# Plan Change Request

Site Address/ Parcel #: 0420331121 Permit #: PRCCP20241189  
Owner: Washington State Fair Email: marty@thefair.com  
Design Engineer: Justin Jones Email: justin@jmjteam.com  
Contractor: Mountain Construction Email: ken@mountainconst.com

➤ Specify the approved civil plans affected: C4-101, C4-103, C4-202, C6-101, C6-102, C6-106

Project:  
**Washington State Fair International Village Redevelopment**

DWG. **C4-101**  
19 of 39

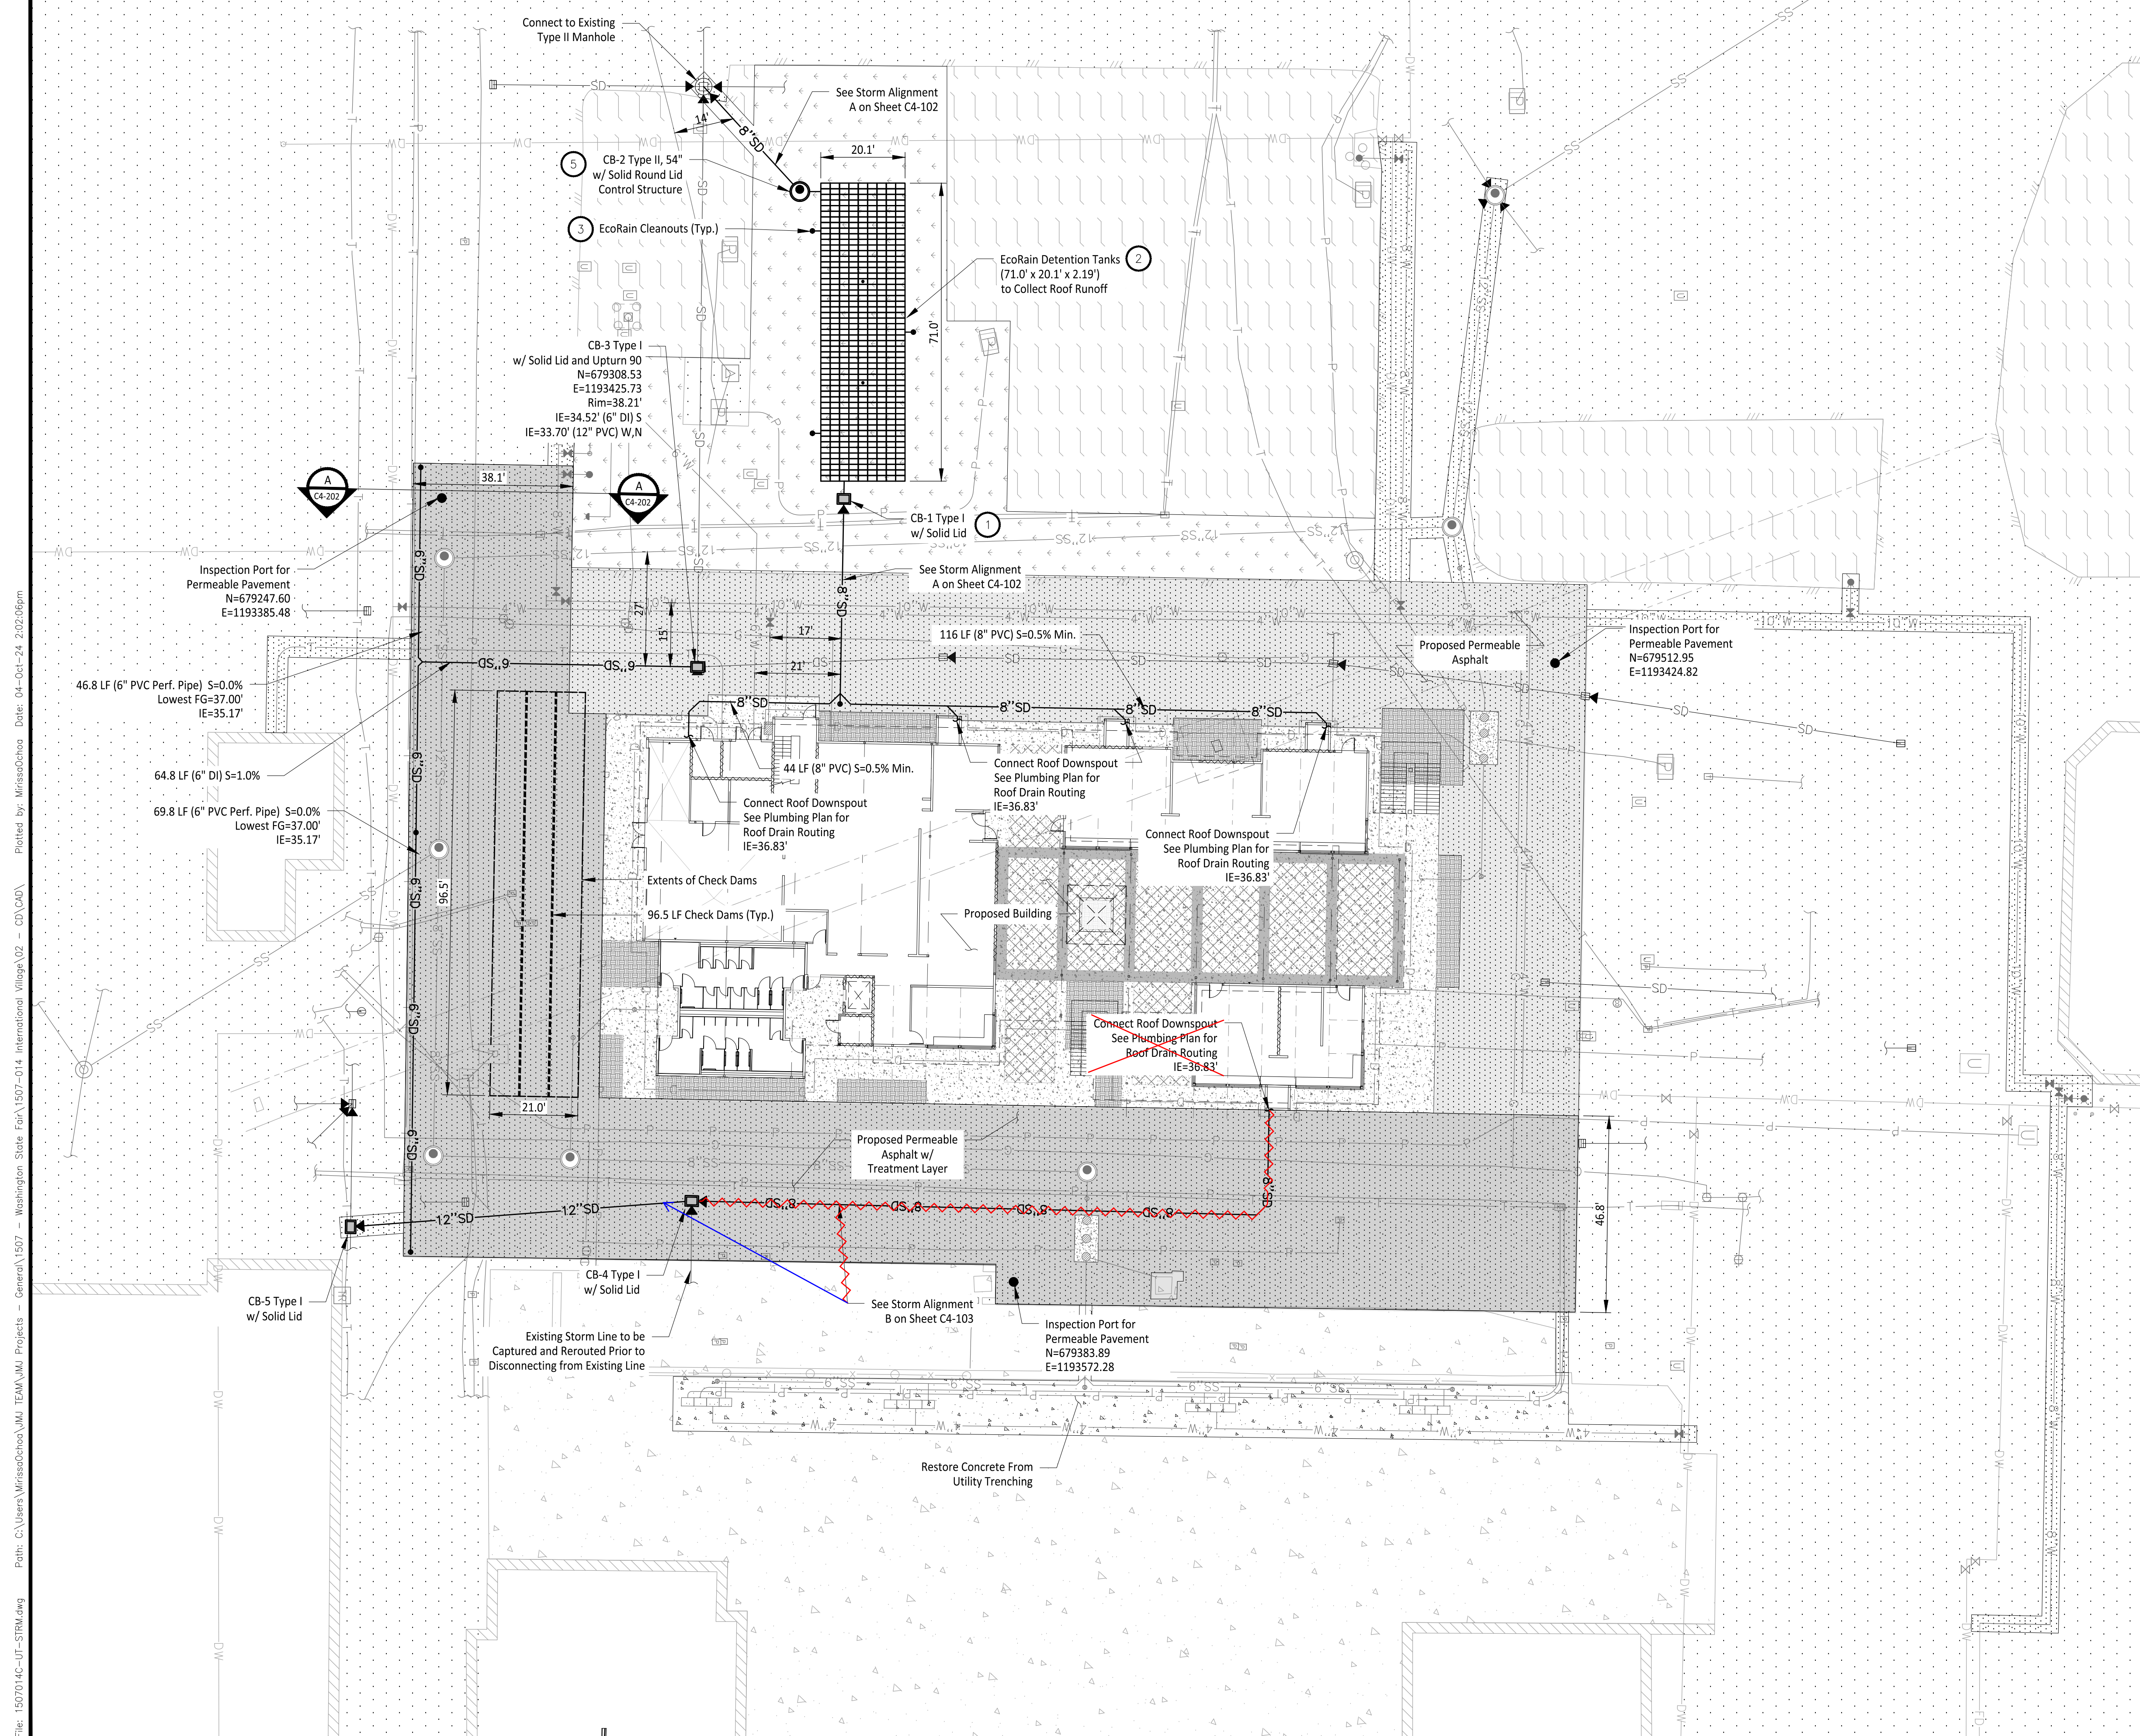
Roof stormwater runoff that previously was bypassing the detention tank, will now be conveyed to the detention tank. The orifices in the control structure have been revised to meet flow control.

DWG. NO.  
**C6-101**  
30 OF 39

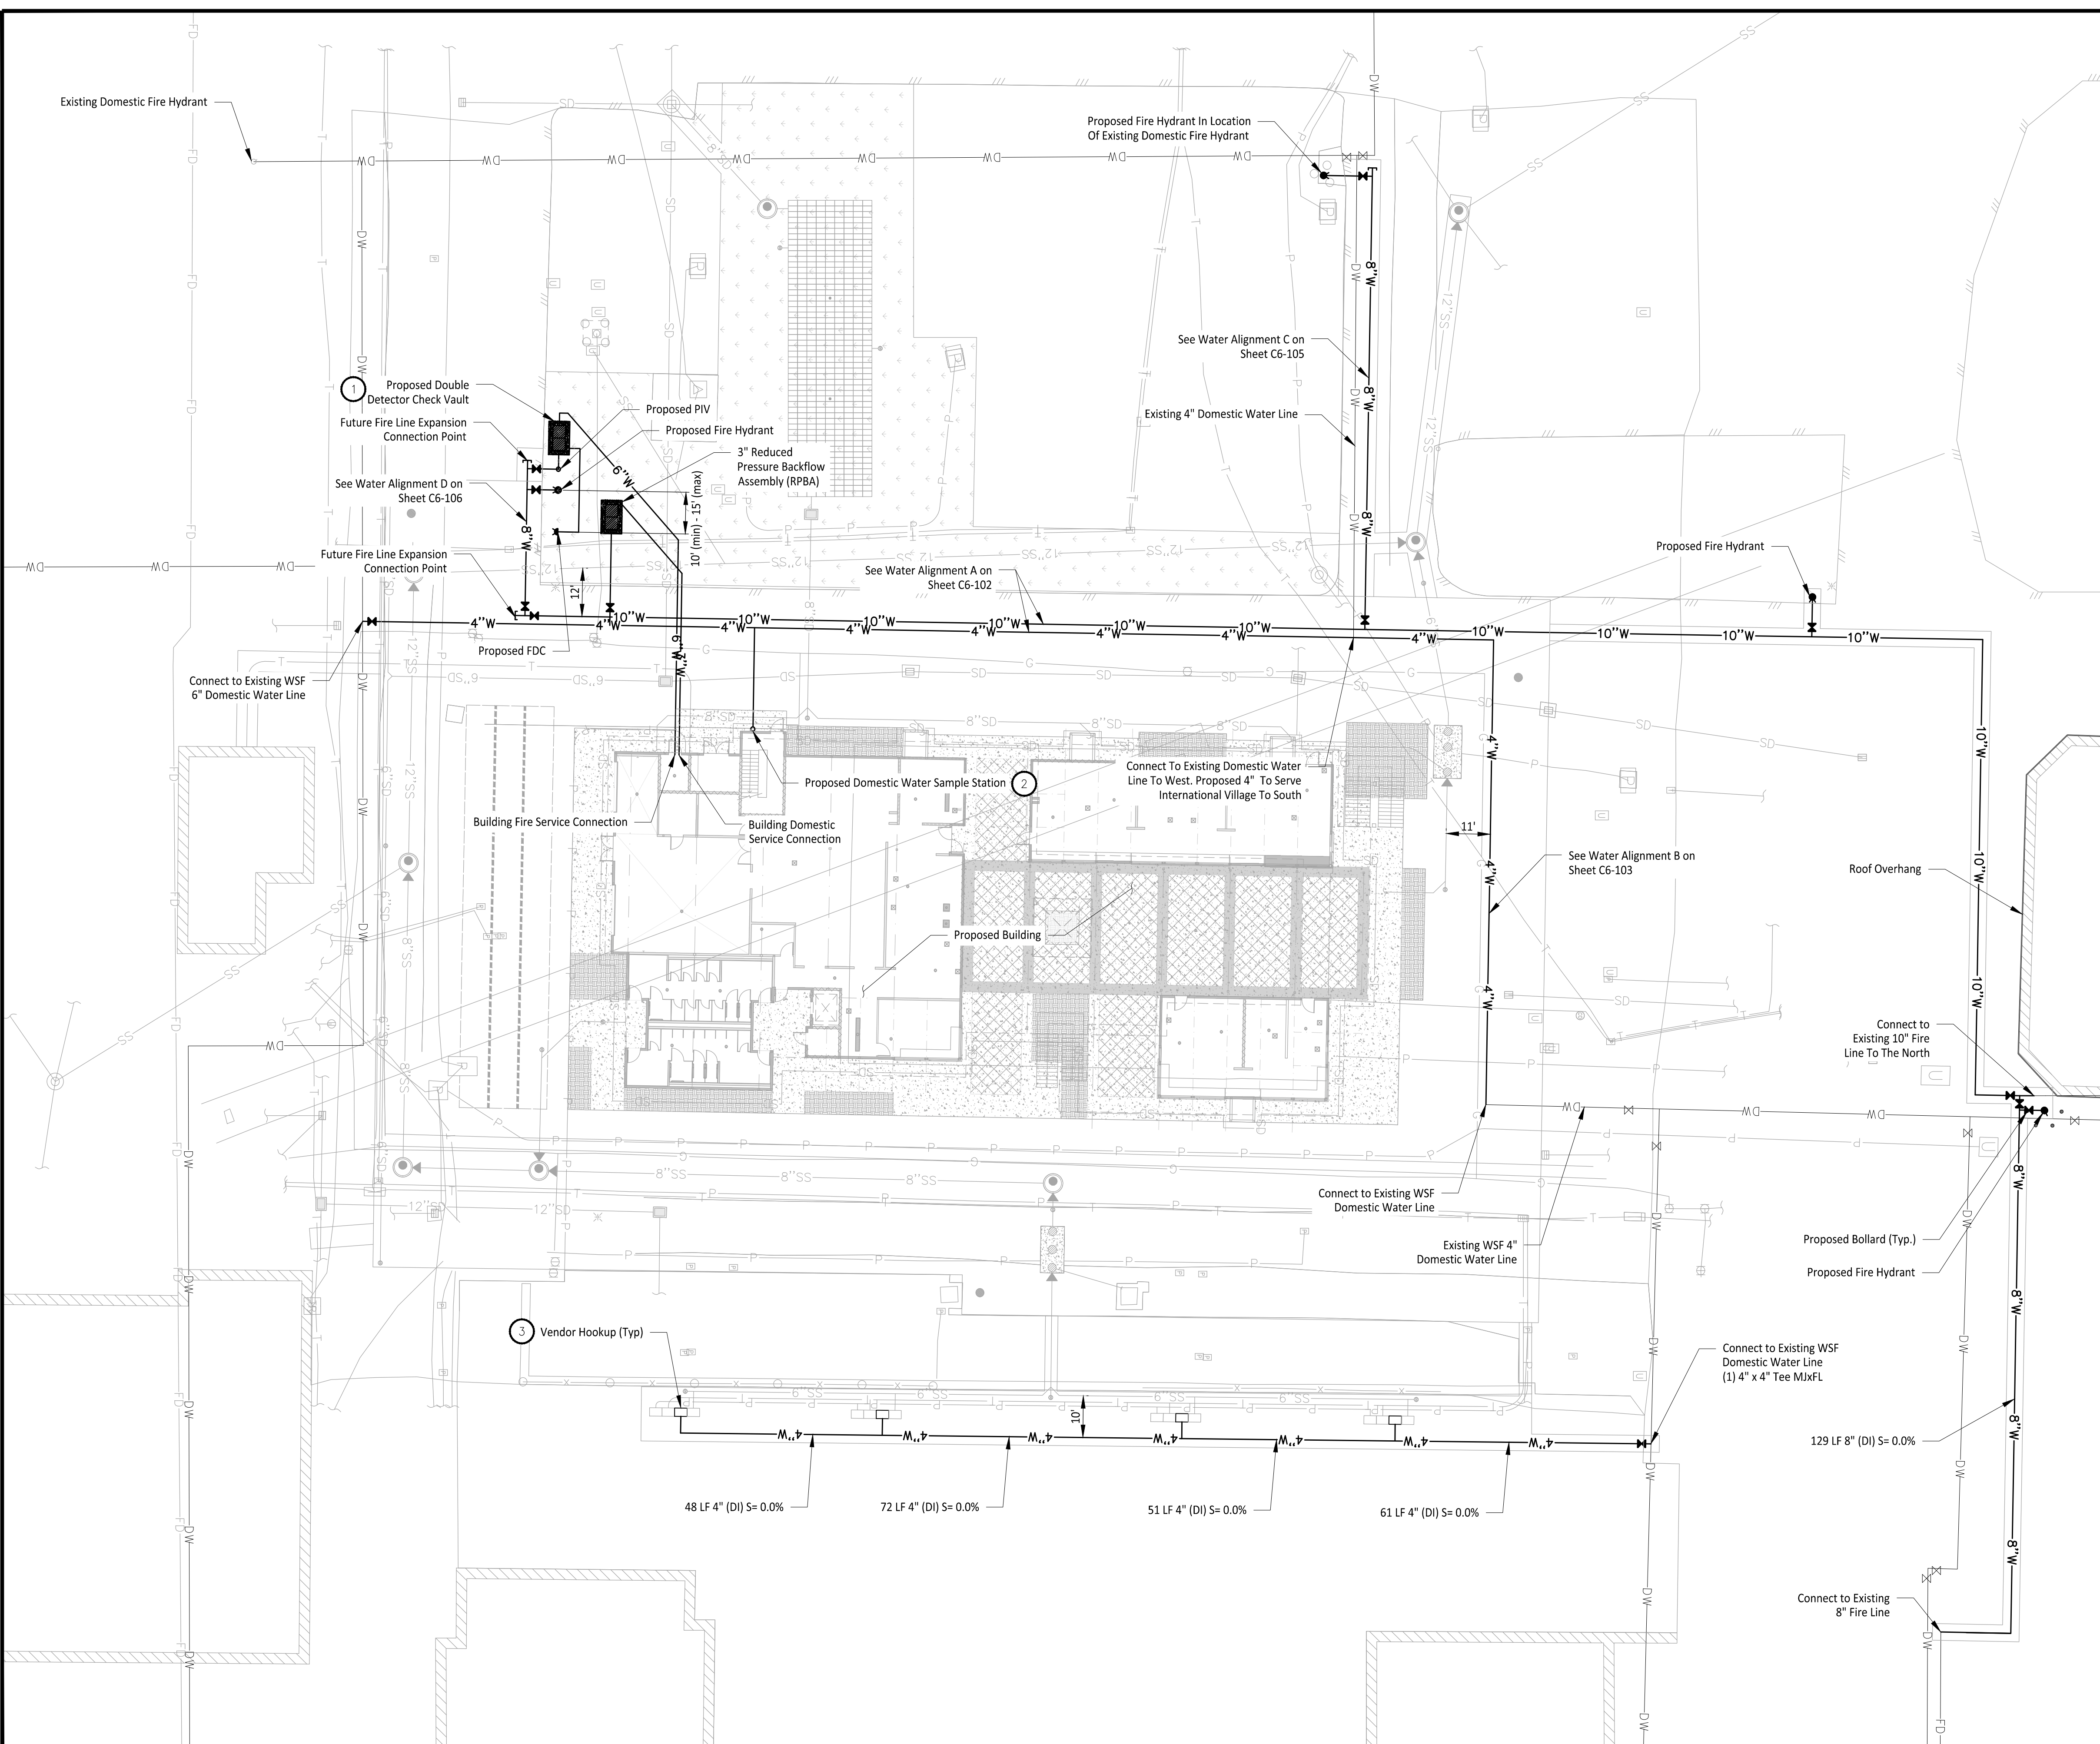
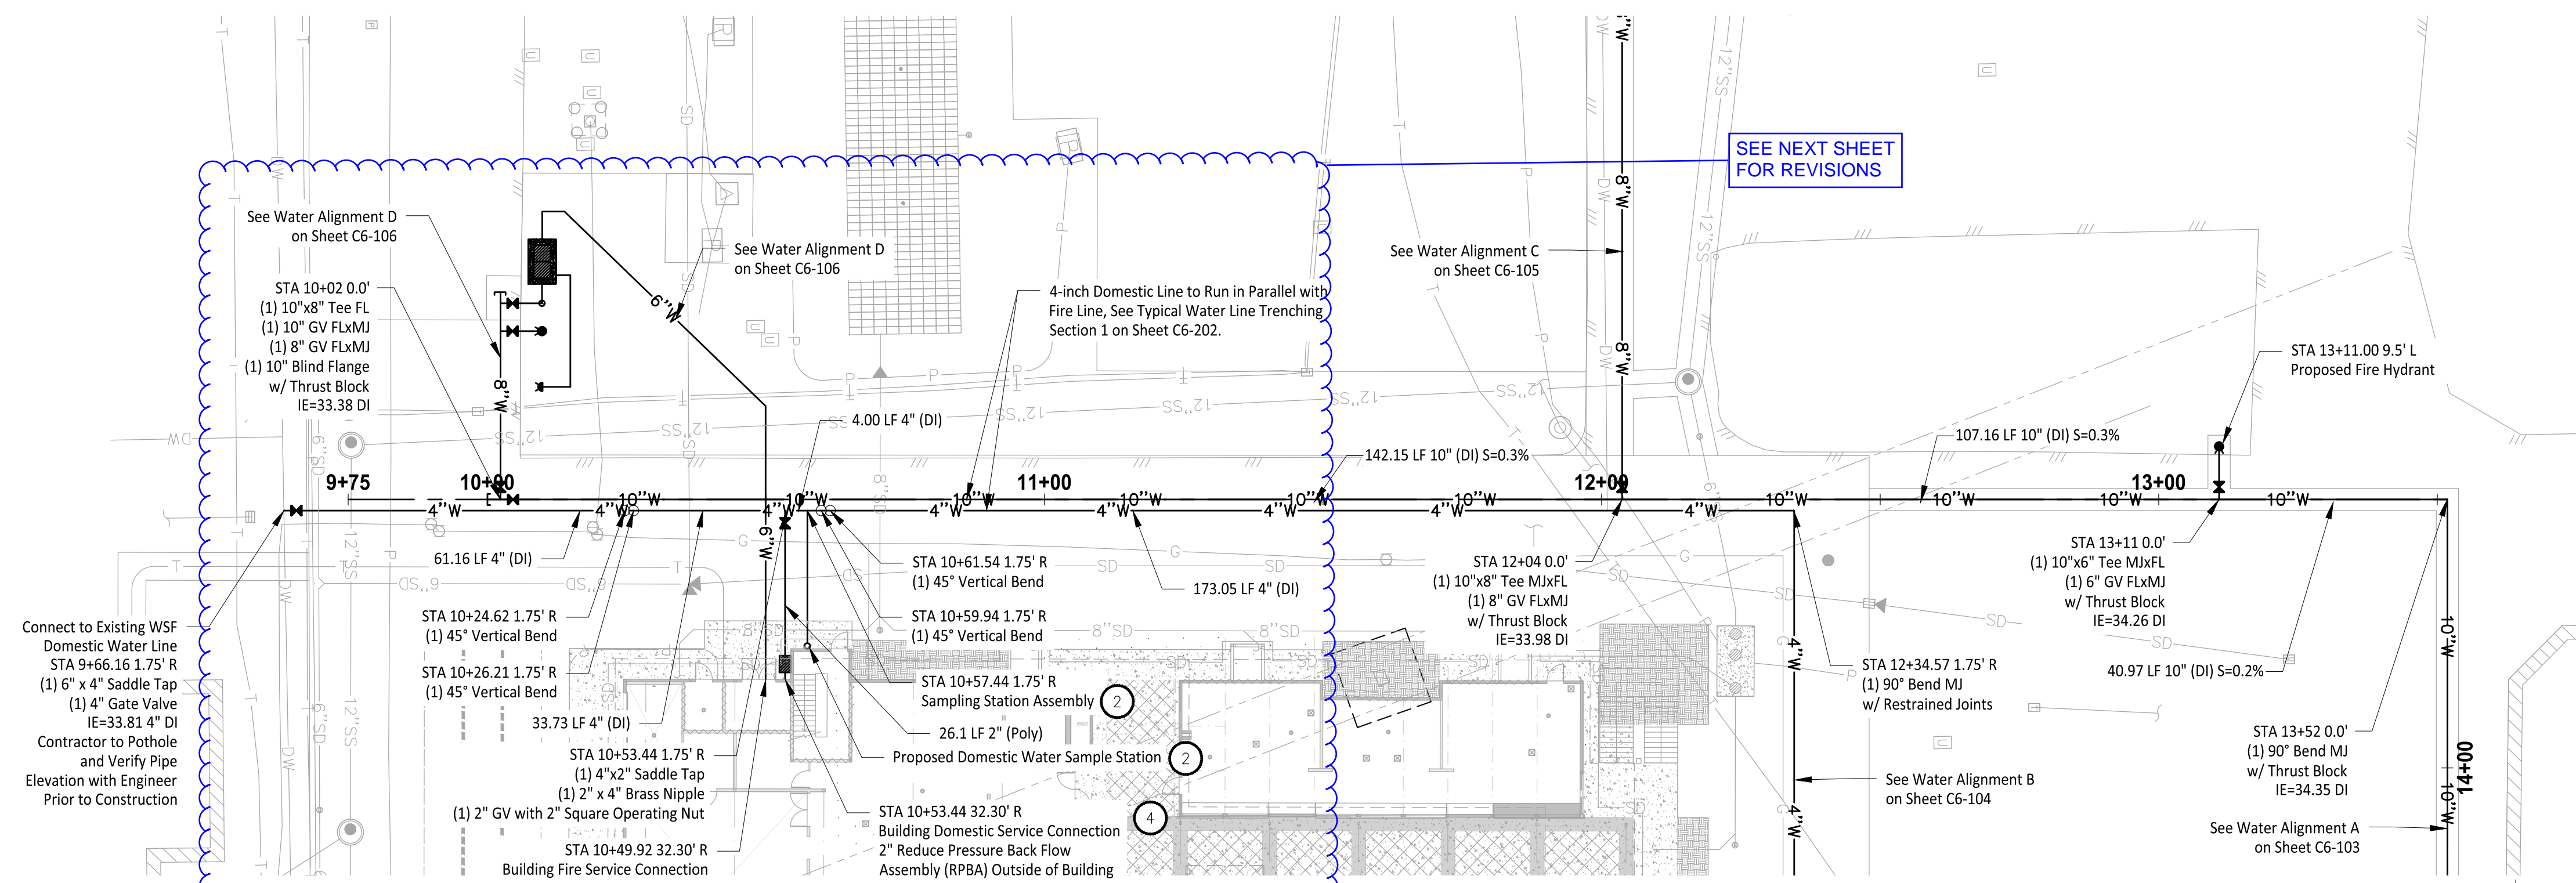
The RPBA has been moved from in front of the west side of the building to the field to the west. Subsequently, the location of the DDCVA will shift within the field.
